Saleen Technical Service Bulletin (STSB)	• REPLACE BOLTS SECURING STRIKER AND HINGES TO HOOD
06-05-01

DATE OF ISSUE: 10/25/2005

MODEL / YEAR: S281 SUPERCHARGED / 2005

ISSUE: HOOD BOLTS MAY BECOME LOOSE

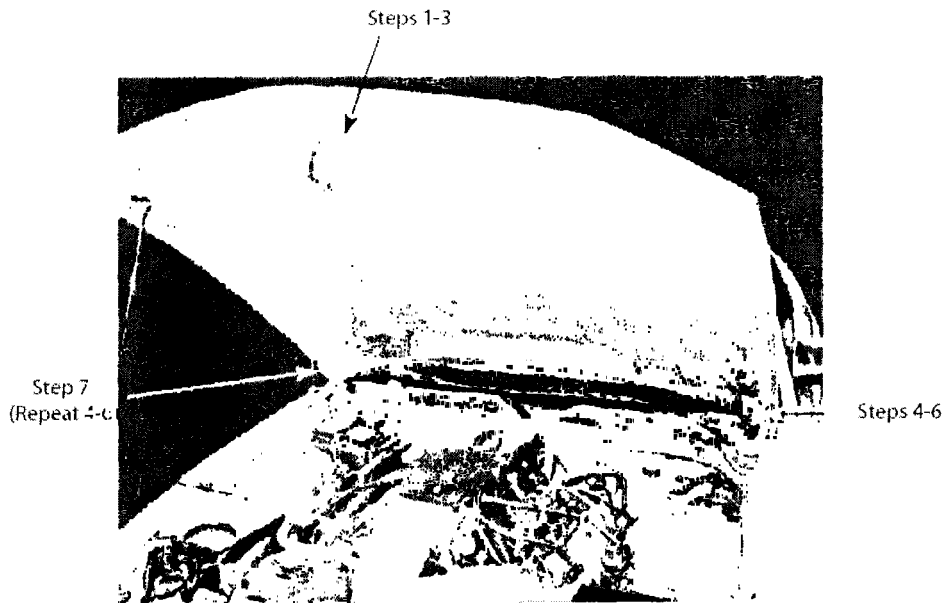
- 1) Remove striker bolts, shown in Figure 1, using ratcheting wrench with 10 mm socket

Striker bolts
